**SUBJECT:** NuScale Power, LLC Response to NRC Request for Additional Information No. 232 (eRAI No. 9113) on the NuScale Design Certification Application

## Response to Request for Additional Information Docket No. 52-048

**eRAI No.:** 9113

Figure 1: MS line weld locations

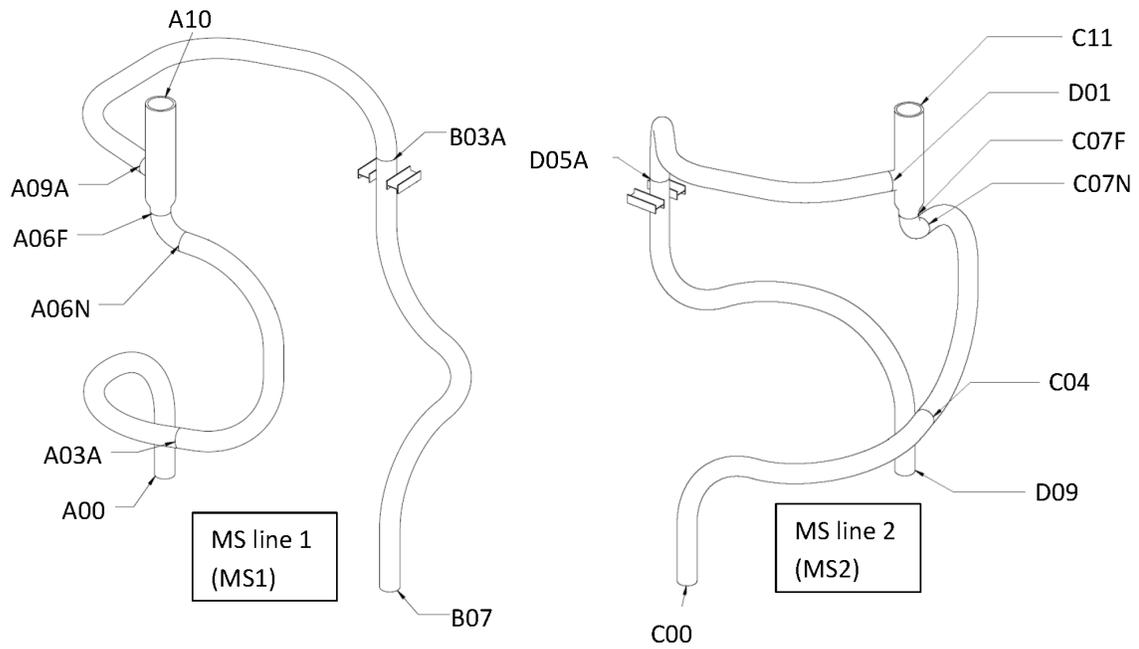
The equations presented in FSAR Section 3.6.3.3 have been used to generate the SBAC Figures referenced in FSAR Section 3.6.3.4 showing normal operating (N) and maximum (N+SSE) stresses for LBB locations. Many of these graphs presented in Figures 3.6-23 through 3.6-32 are unusual in that the maximum (N+SSE) stresses are lower than the normal stresses for some cases. To assist the staff in understanding these graphs, please provide the following;

- Provide a table of stresses or forces and moments at the girth weld (node points) from the piping stress analysis and indicate which of these locations are used in the LBB analysis. In these tables, also identify the different stress components, i.e., thermal expansion, pressure, dead-weight, seismic/inertial, seismic/anchor motion, etc.
  - The normal stress versus maximum stress plots shown Figure 3.6-23 to Figure 3.6-32 for various segments for MS and FW system show that there were some data points below 1:1 line indicating that N+SSE stresses are lower than normal stress. Please explain.
-

The weld locations on main steam (MS) and feedwater (FW) lines are shown in Figures 1 and 2, respectively. All weld locations are included in the LBB analyses. Forces and moments at these locations are tabulated in Tables 1 and 2 for MS and FW, respectively. In these tables, loads are calculated based on the local Cartesian coordinate system at each weld location; Fa is axial force and Mr is resultant moment.
